# Access Compliance Report

## Public Rights-of-Way

### (Curb Ramps)

Intersection ID: 30448	Main Street: NANNYBERRY_LN	Cross Street: WALLAND_LN	Location: SW
ADA ID: 8C66A3EBC77E	Ramp Type: PerpDiag	Initial Pass/Fail: Fail	Overall Compliance: No
Severity Score: 21.25			
Codes/Mitigation Info/Possible Solution		Field Measurements/Component Compliance

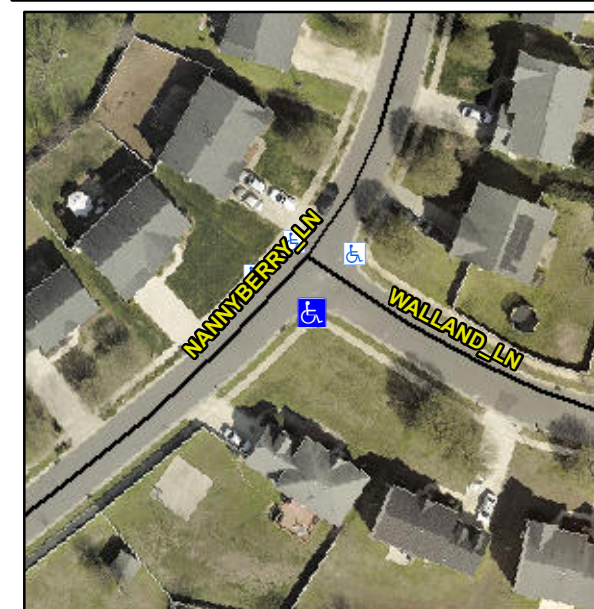
**Remove & Replace Curb Ramp With Two New Directional Ramps or Equivalent.**

**R304.5.1, R304.5.3**

Compliance	Description	Data	Compliance	Description	Data
N/A	Ramp Length (in)	47.0	Yes	Ramp Slope (%)	5.2
No	Ramp Width (in)	45.0	No	Ramp XSlope (%)	5.7
N/A	Flare Type LT	N/A	N/A	Flare Type RT	N/A
N/A	Flare Slope LT (%)	N/A	N/A	Flare Slope RT (%)	N/A
N/A	Flare Traversable LT?	N/A	N/A	Flare Traversable RT?	N/A
N/A	Landing Length (in)	N/A	N/A	DWS Provided?	N/A
N/A	Landing Width (in)	N/A	N/A	DWS Contrast?	N/A
N/A	Landing Slope (%)	N/A	N/A	DWS Length (in)	N/A
N/A	Landing X Slope (%)	N/A	N/A	DWS Full Width?	N/A
N/A	Landing Curb? (Y/N)	N/A	N/A	DWS Offset (in)	N/A
N/A	Shared Landing?	N/A			
N/A	Gutter Ponding?	N/A	N/A	Gutter Slope (%)	N/A
N/A	Gutter Lip Ht (in)	N/A	N/A	Gutter X Slope (%)	N/A
N/A	Painted X Walk1?	No	N/A	Painted X Walk2?	No
	X Walk 1 Direction	To NE		X Walk 2 Direction	To NW
N/A	X Walk 1 Width (in)	N/A	N/A	X Walk 2 Width (in)	N/A
	X Walk 1 Slope (%)	0.4		X Walk 2 Slope (%)	0.7
	X Walk 1 X Slope (%)	4.0		X Walk 2 X Slope (%)	1.6
